Service Manual

Drum Type Washing Machine

NA-148VB3-WGB
NA-148VB3-WGN
NA-148VB3WPG

Subject: Hinge Support Sheet

Old Front Panel Door Lock Hole (left) vs New Front Panel Door Lock Hole (right)

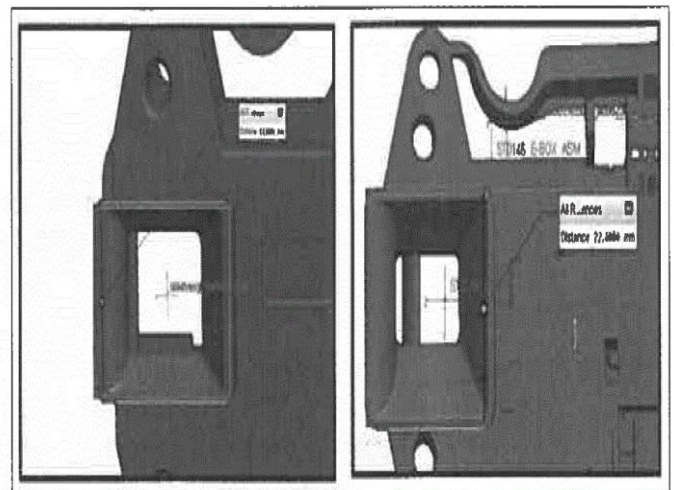
In order to minimize the effect of the declination of door group,door lock window has been re-designed by expanding. Door lock hole will stay the same size, while the hook area is to be expanded.

Door lock window on the front panel will be expanded accordingly.

Figures 4. and 5. The new support sheet design (hung on panel)

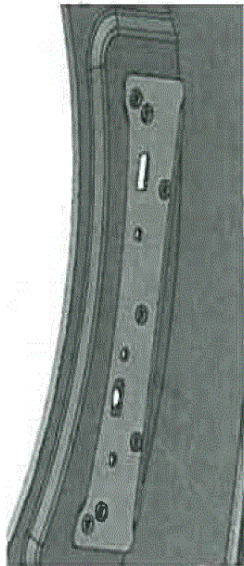
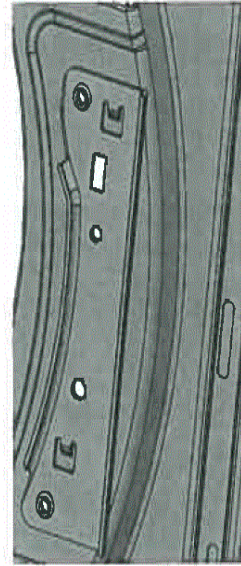
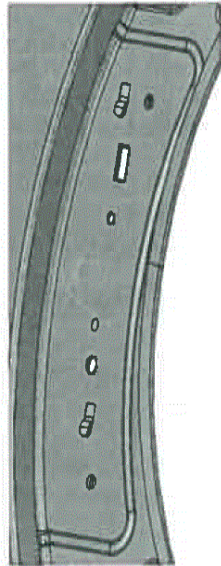
Hinge support sheet

The thickness is increased from 1mm to 2mm in the areas mentioned.
